ORIGINATION FORM

Proposed Revisions to a Standard Plans Index

Index Number: 700-090

Index Title: Dynamic Message Sign Walk-In

LAST REVISION	DESCRIPTION:	 FY 2022-23 STANDARD PLANS	DYNAMIC MESSAGE SIGN WALK-IN	INDEX 700-090	SHEET 1 of 5
11/01/22

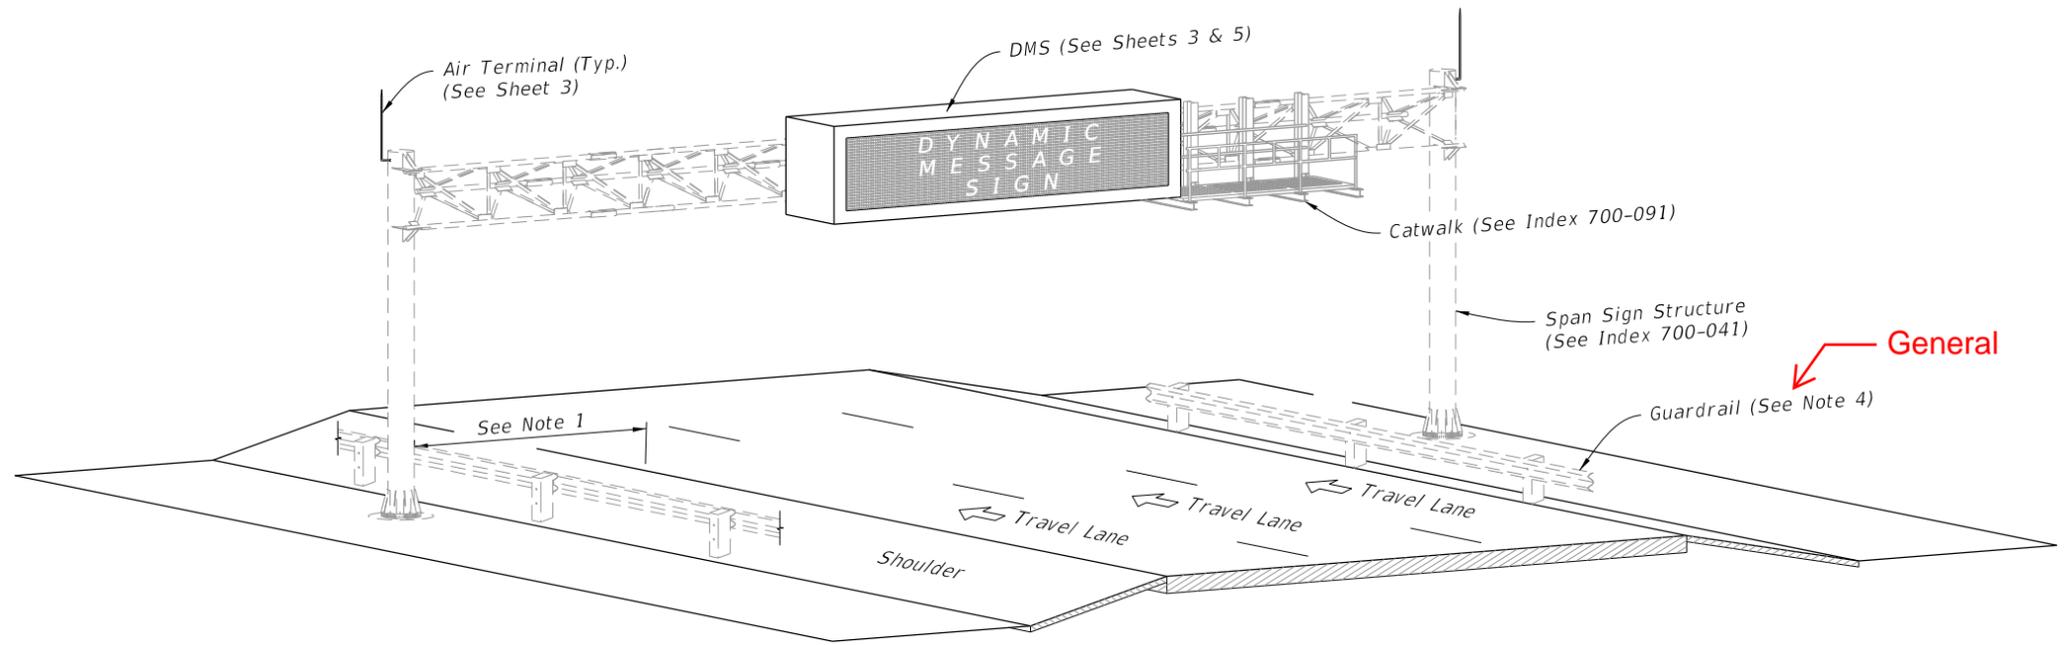
Updated General Note 1 - "Meet the requirements of Specification 700."; Deleted Note 5; Renumbered General Notes.

1. ~~Work this Index with Specification 700.~~
2. Furnish and install the Dynamic Message Sign (DMS), sign structure in accordance with Index 700-040 or 700-041. Locate foundations at locations shown in the Plans.

5. ~~Materials:~~
 - A. ~~Sign Mounting Components:~~
 - a. ~~Aluminum Structural Shapes: ASTM B221, Alloy 6061-T6~~
 - b. ~~Vertical Hangers: ASTM A704, Grade 36~~

GENERAL COMMENT: Material information was deleted. Information is either already covered in Standard Specifications OR will be added to Section 700, 962 or 965 in conjunction with these revisions.

UPDATED NOTE: Meet the requirements of Specification 700.

DELETED
